PROJECT :-
CORNER WALK
AT SECTOR- 74, GURUGRAM

DRAWING TITLE		TYPICAL FLOOR(7th,9th,11th,12th, 14th,15th & 17TH.) FRAMING PLAN									
DRAWING NO. :-		5	1	8	2	2	1	5	1	1	A
SCALE: AS SHOWN		DATE: 16.02.2021					SHEET NO :- (01 OF 01)				
DRAWN BY: SSB		DESIGNED BY: SJ					APPROVED BY :- AGU				
STATUS :- GOOD FOR CONSTRUCTION							REVISION NO. :- R2

DRAWING TITLE	TERRACE FLOOR LEVEL FRAMING PLAN
DRAWING NO. :-	5 1 8 2 2 1 5 1 4 A
SCALE:	AS SHOWN
DATE:	26.07.2021
SHEET NO. :-	(01 OF 01)
DRAWN BY:	SSB
DESIGNED BY:	SJ
APPROVED BY:	AGU
STATUS :-	GOOD FOR CONSTRUCTION
REVISION NO. :-	R2

TERRACE FLOOR LEVEL FRAMING PLAN
(SCALE 1:150)

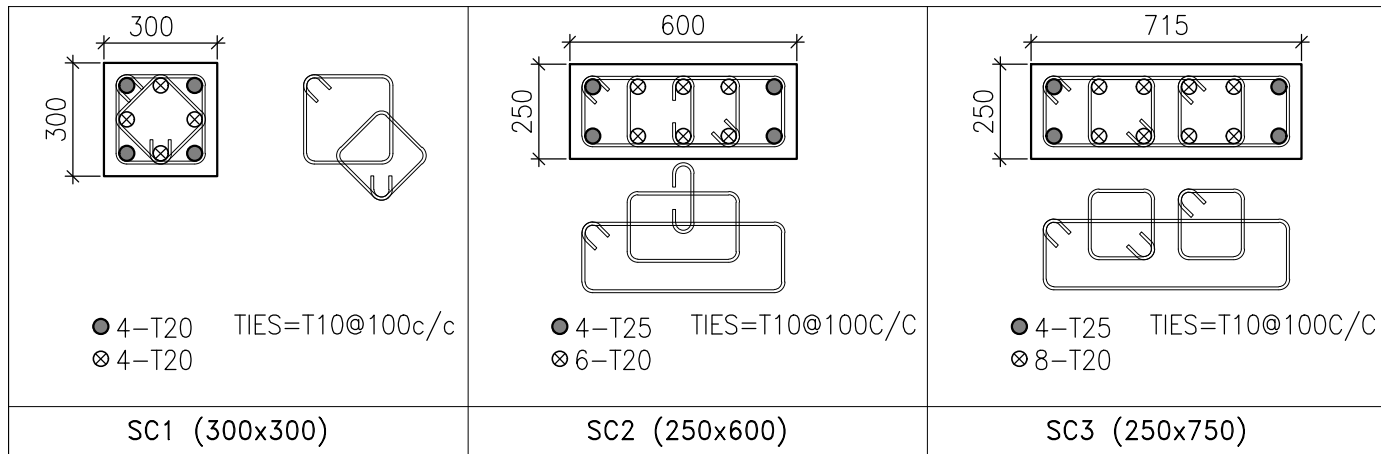
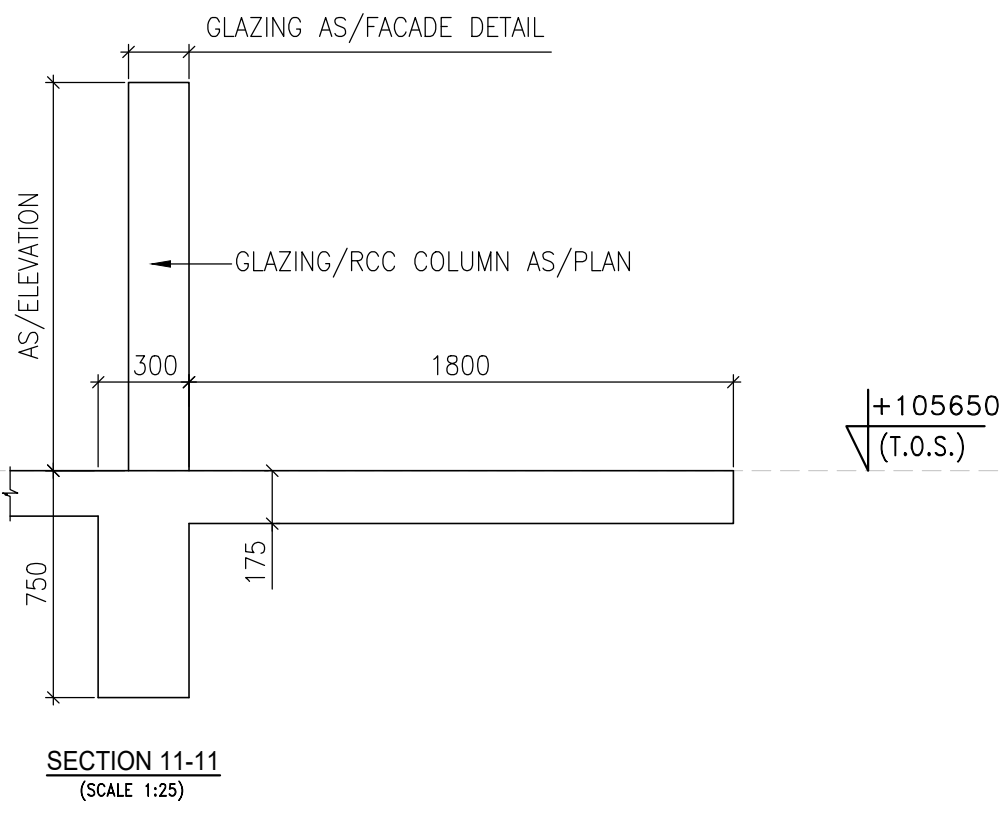
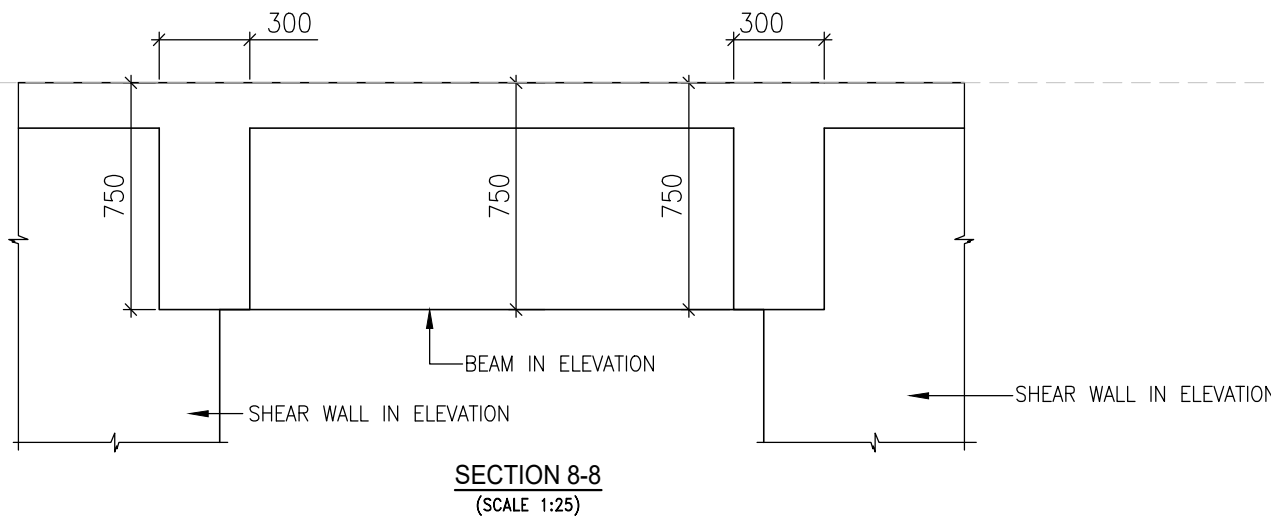
COOLING TOWER SECTION REQUIRED
FRAME SHOULD BE IN STEEL OR CONCRETE ??
